RE: Request for Proposals (RFP) – Longview Pharmacy

ADDENDUM NO. 2

Project Name: Cowlitz Indian Tribe Longview Pharmacy
Aetta Project #: 25065
Date: 06/10/2026

AD201

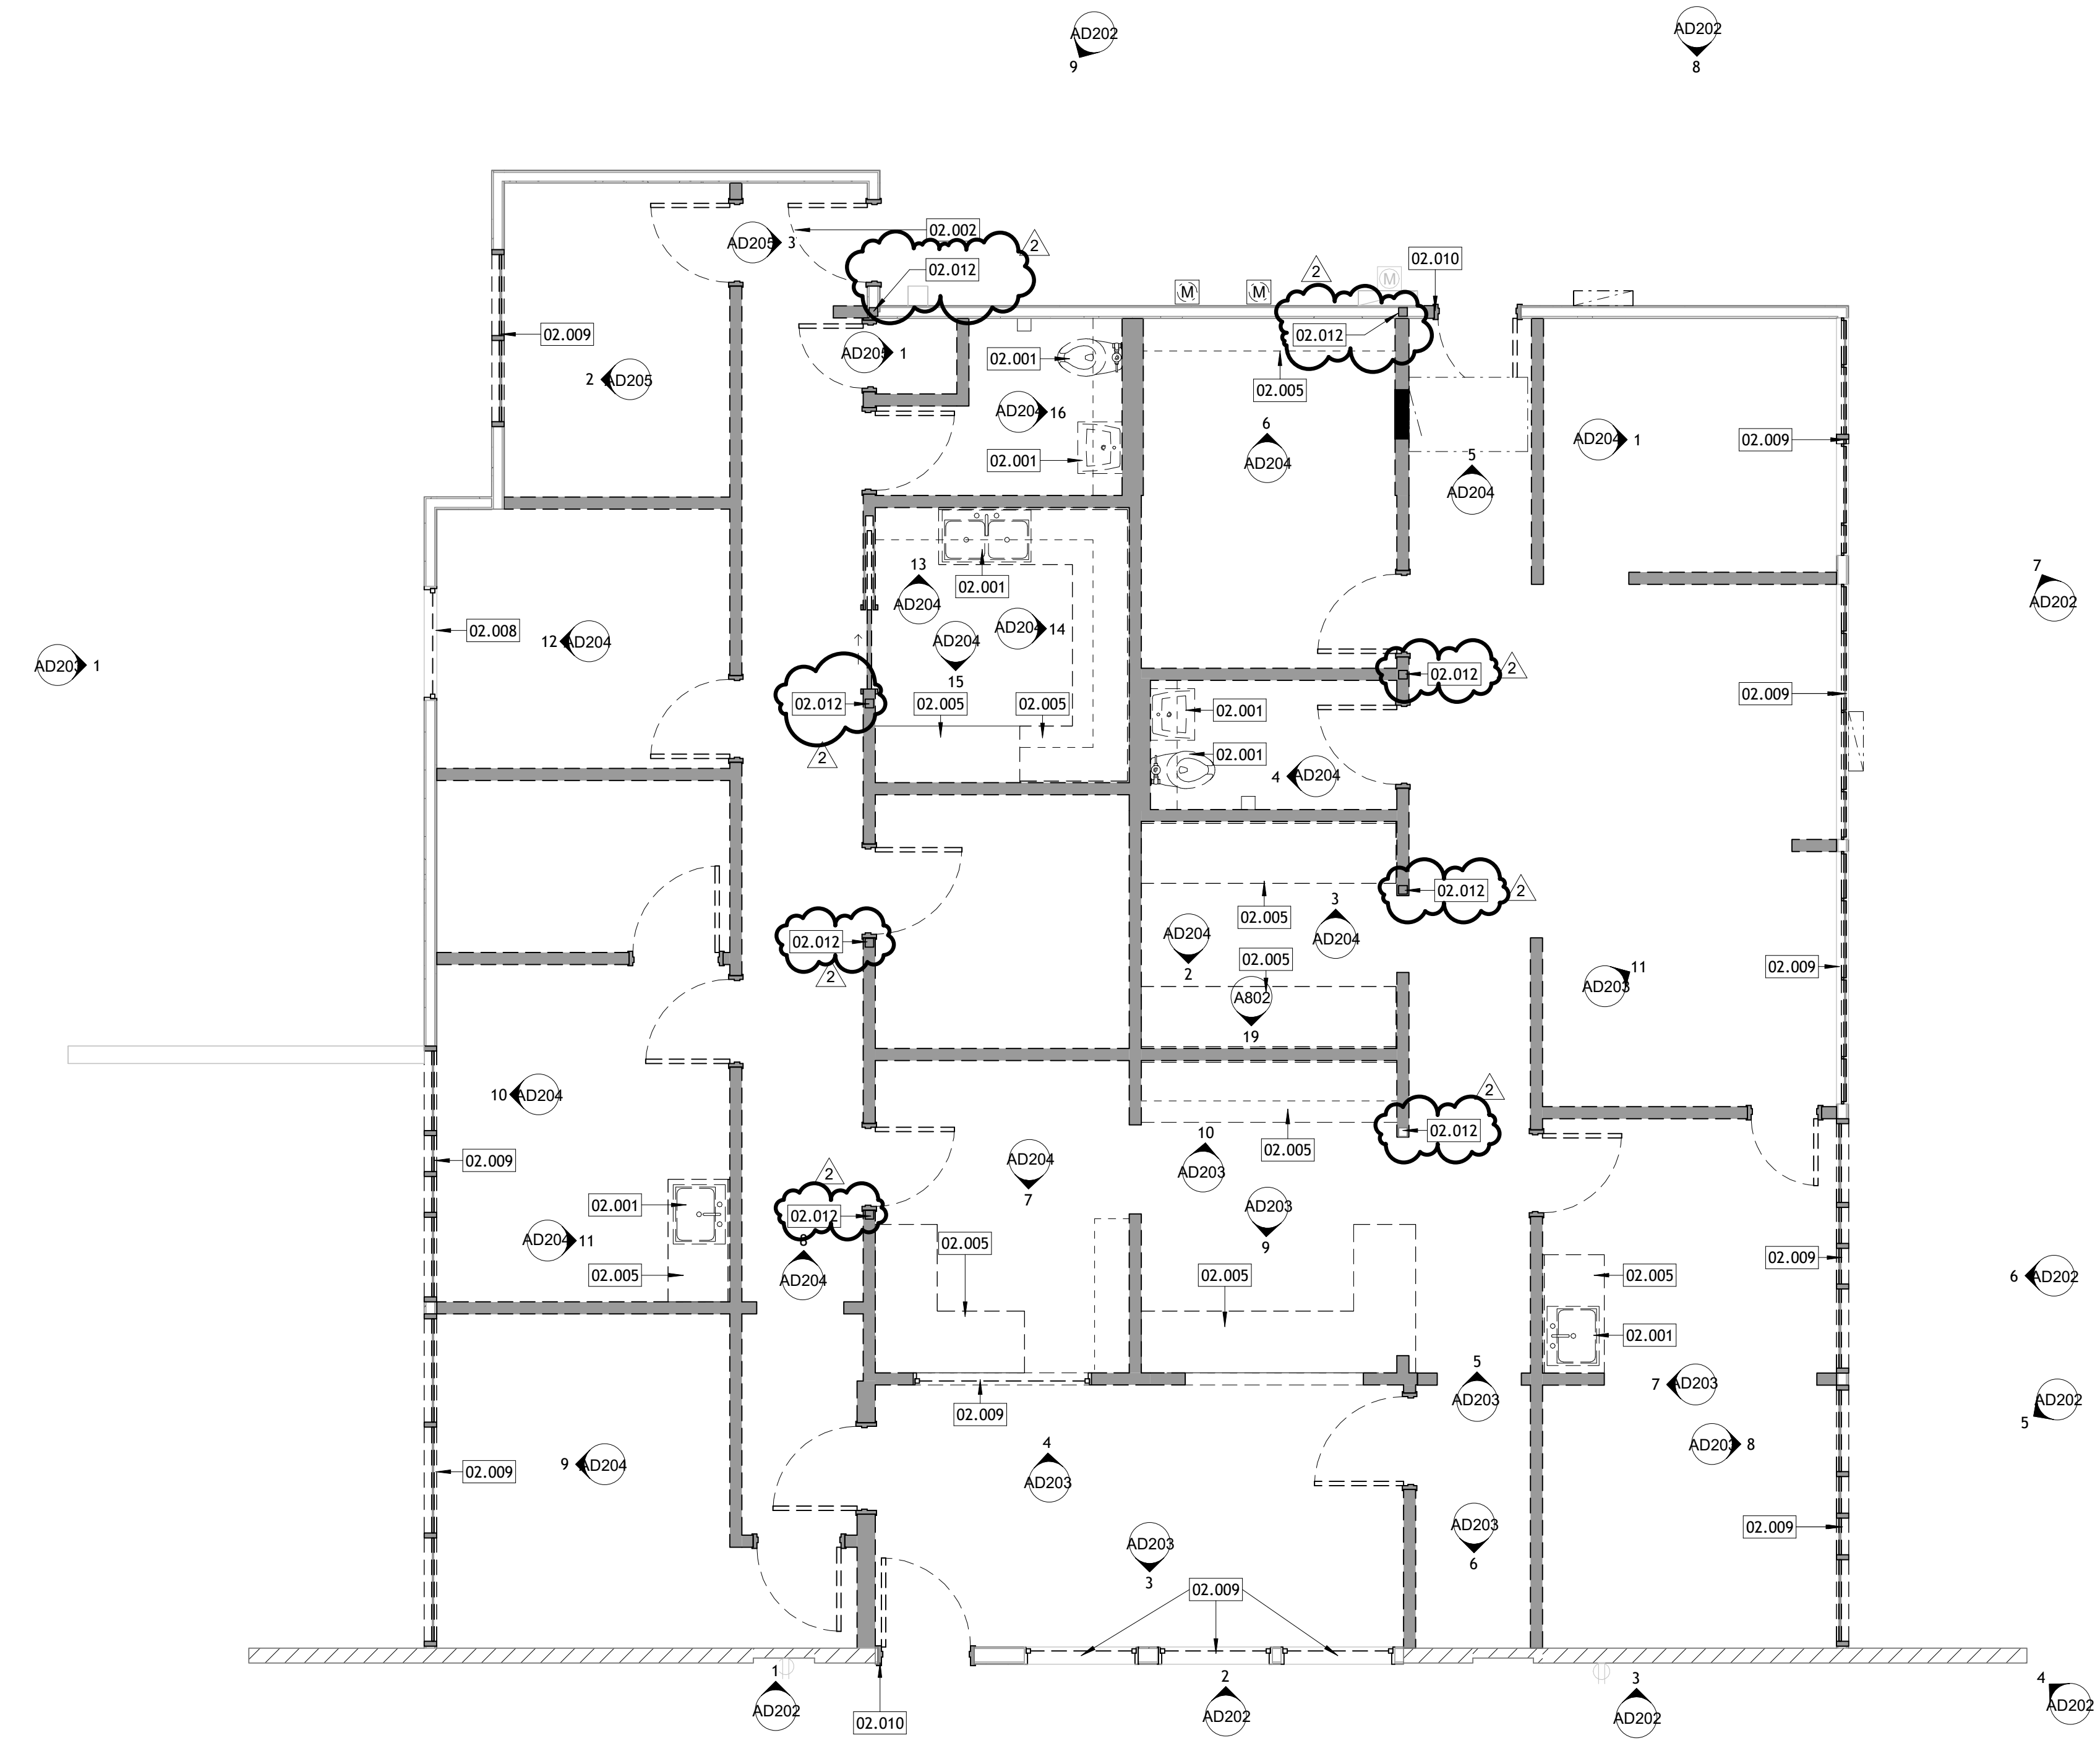
Q. Plan sheet AD201 keynote 02.006 is referenced at two existing columns that are shown to remain. Structural Foundation Plan S201 appears to show these two columns receiving new footings. Is this a correct understanding of the plans?

| Item #: | Sheet/Detail: | Description: |
|----------------|----------------------|---|
| 1.02 | AD201 | REVISE sheet for column keynotes |

A. See updated sheet AD201 in Addendum #2 for revised callouts.

A1001

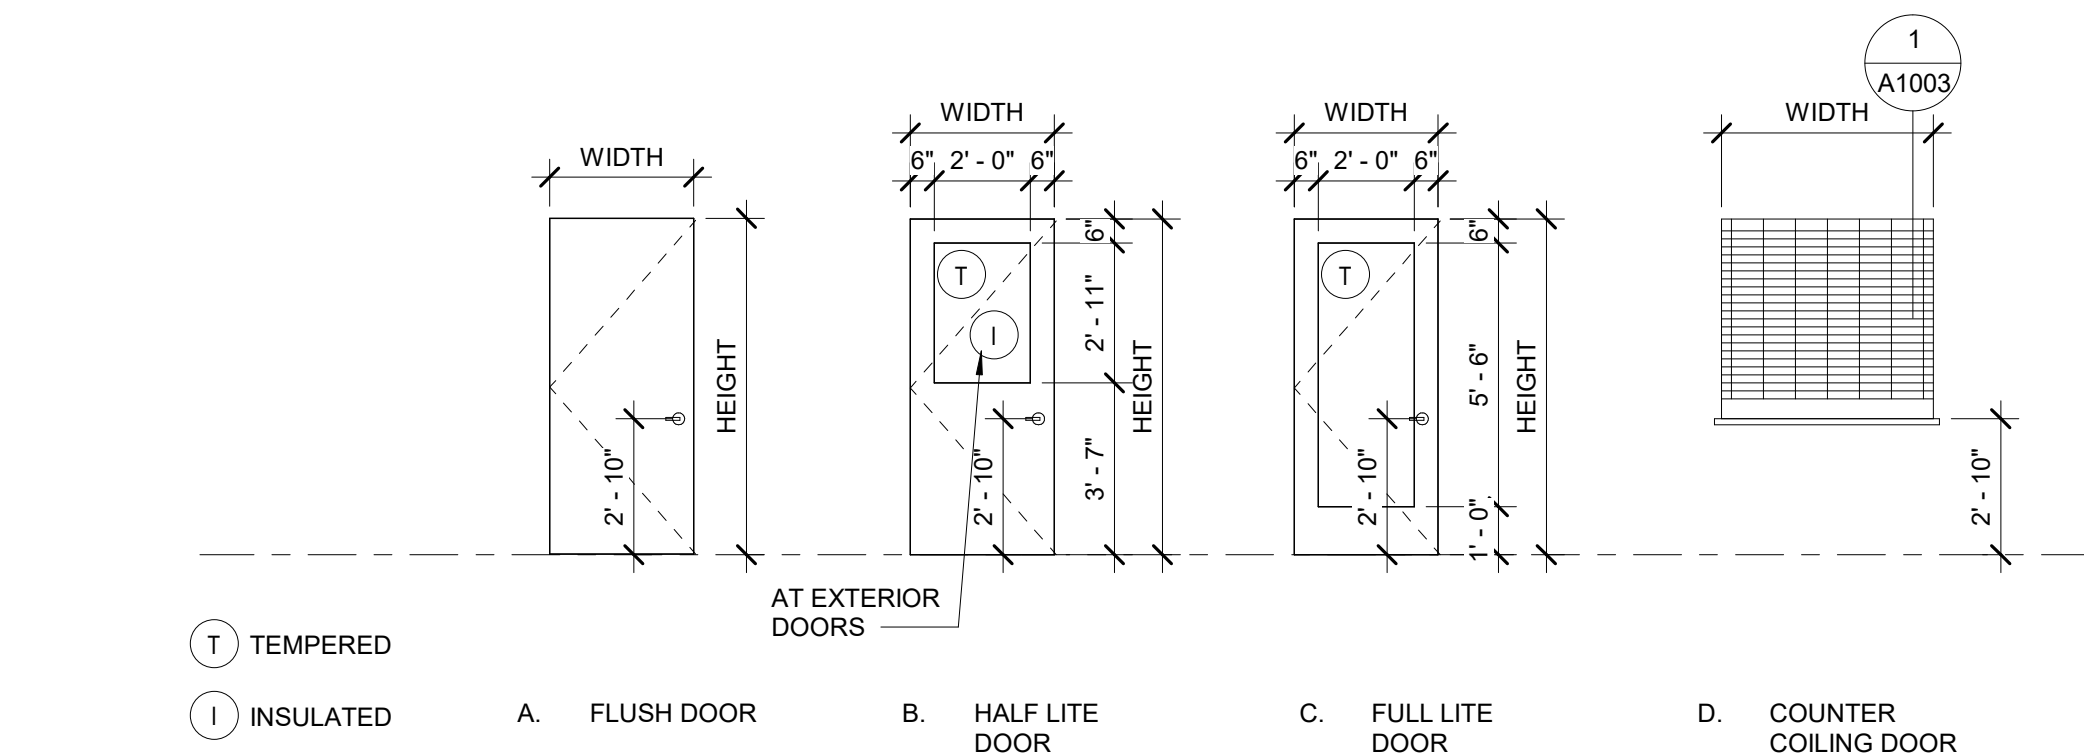
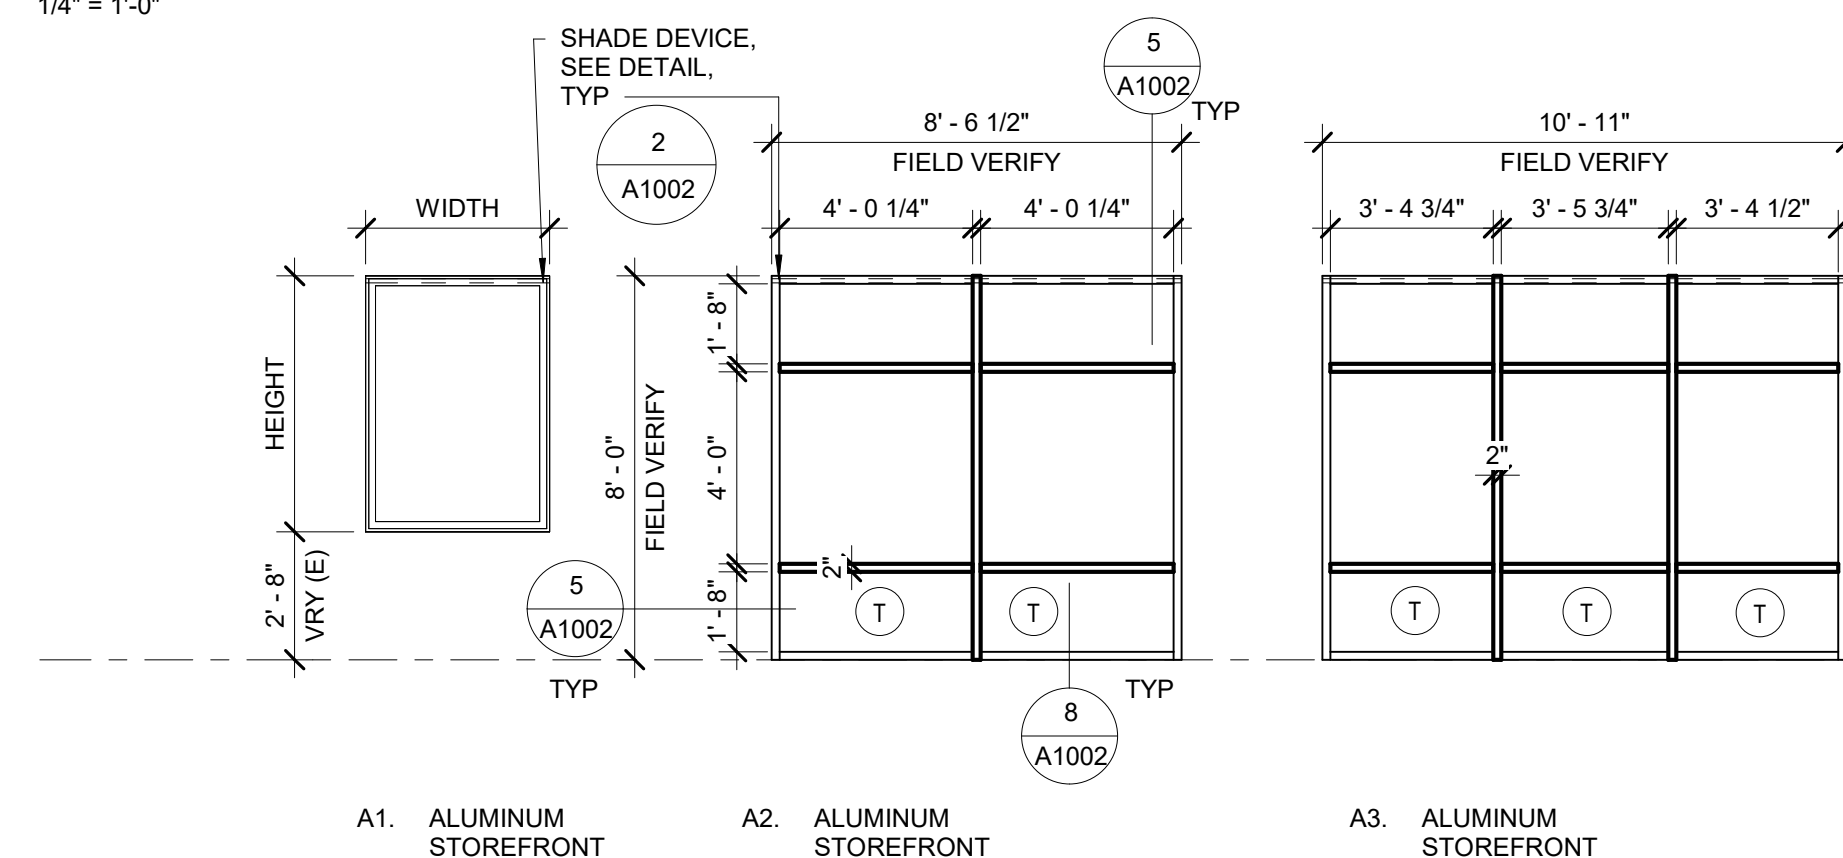
Q. Plan sheet A201 references door # 107B whereas the Door Schedule on plan sheet A1001 does not show specifications for door # 107B. Please provide information as to the size and specifications for door #107B.

Q. It appears that the existing door opening at door # 107B is being widened. If this is correct, please provide specifications and sizing for a new door header above this opening. Also, the exterior elevation will need to show siding infill above the door if the new door is not 8' tall (exterior elevations appear to show a 7'-0" tall door whereas the existing door at this location is currently 8' tall).

| Item #: | Sheet/Detail: | Description: |
|----------------|----------------------|---|
| 1.05 | A1001 | ADDED door #107B to door schedule |

A. New door is 8'-0". The required header size and all connection details can be found on detail 3/S601.

A. New door is 8'-0". The required header size and all connection details can be found on detail 3/S601.
